SUBJECT: Palisades Nuclear Plant Third Six-Month Status Report in Response to
March 12, 2012 Commission Order Modifying Licenses with Regard to
Reliable Spent Fuel Pool Instrumentation (Order Number EA-12-051)

Palisades Nuclear Plant
Docket No. 50-255
License No. DPR-20

Palisades Nuclear Plant Third Six-Month Status Report in Response to March 12, 2012 Commission Order Modifying Licenses with Regard to Reliable Spent Fuel Pool Instrumentation (Order Number EA-12-051)

An updated sketch of the SFPI arrangement showing the current Channel A and Channel B cable routings is provided below in Figure 1.

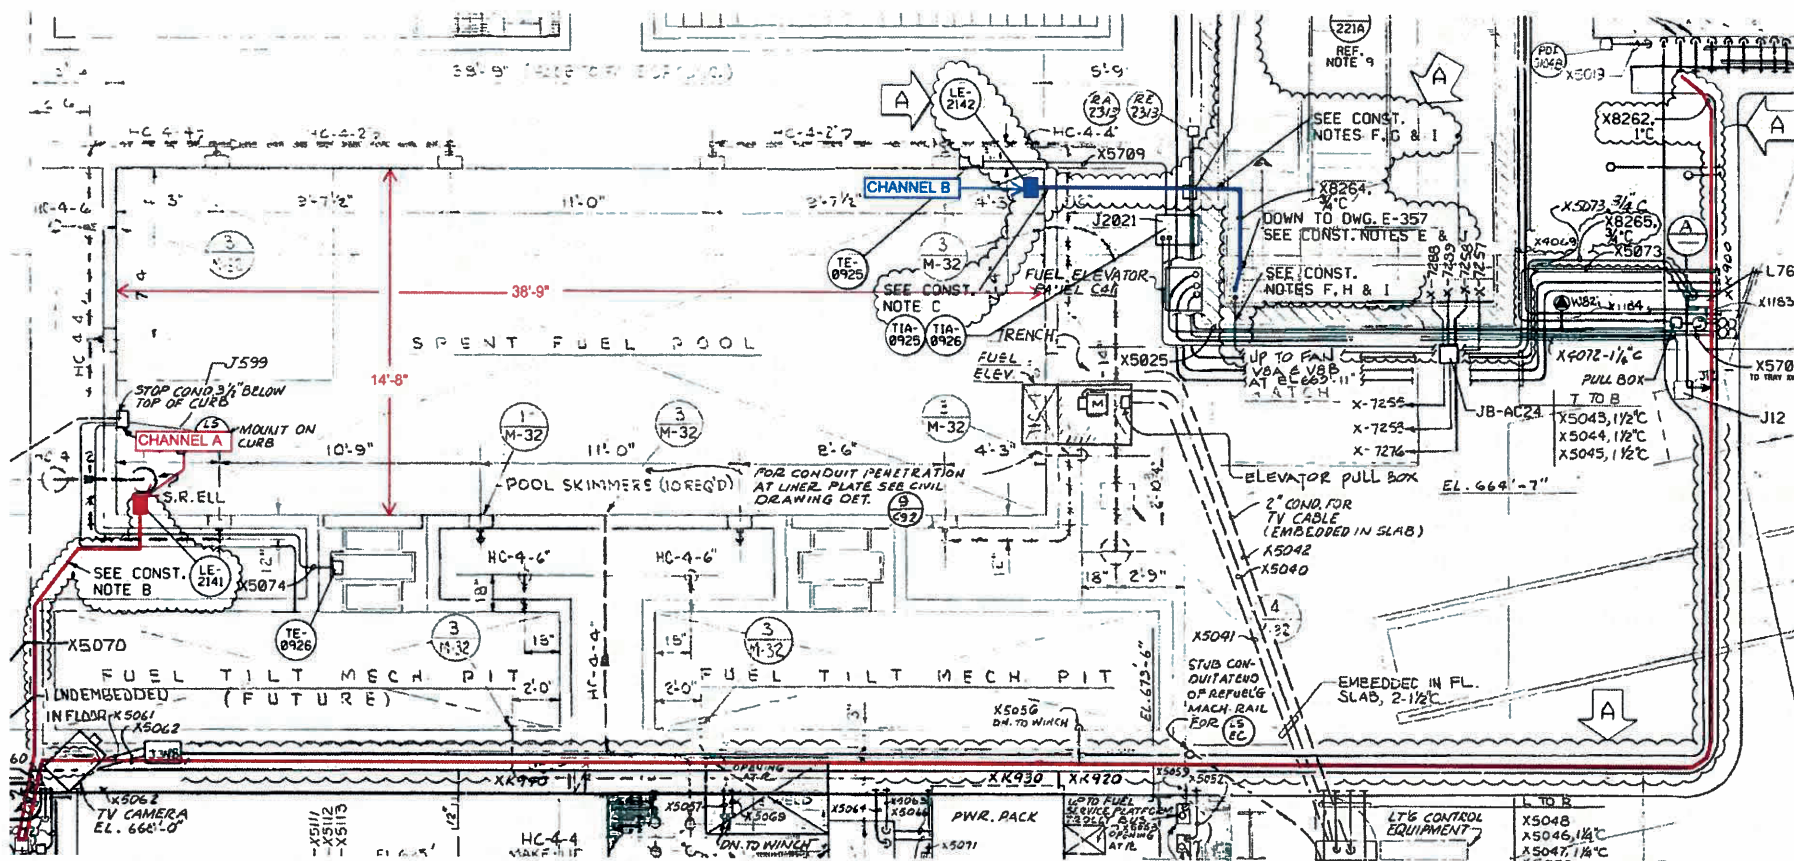
Section 3.4 of the Interim Staff Evaluation discusses the arrangement of the SFPI channels and references the sketch in Attachment 1 of the Overall Integrated Plan. As discussed in Section 4, the location of the Channel A level instrument has been moved to the west SFP wall, within 12" of the northwest SFP corner.

Section 3.4 of the Interim Staff Evaluation also refers to a statement that declares cables in the SFP area will be routed in seismically mounted rigid metal conduit. It should be noted that this statement does not apply to the first 20 feet of cable run, which is comprised of SiO₂ stainless steel armored cable, routed in seismically mounted 12 gauge unistrut channel with a closure strip. The SiO₂ stainless steel armored cable then transitions to coaxial cable, at which point the coaxial cable will be installed in seismically mounted rigid metal conduit for the remainder of the run in the SFP area. This cable installation is applicable to both Channel A and Channel B.

Attachment 1 of the Overall Integrated Plan (Reference 1 in Section 8) shows Channel A mounted against the north wall near the northwest corner of the Spent Fuel Pool (SFP). The location of Channel A has been moved to the west wall near the northwest corner of the SFP. See Section 7 for additional discussion. Section 7 also contains a figure with the new cable routing for the SFP area.

The Overall Integrated Plan states in Section 6 that SFPI cables in the SFP area shall be routed in seismically mounted rigid metal conduit. This is true for the coaxial cable, but does not apply to the SiO₂ stainless steel armored cable. See Section 7 for additional discussion.
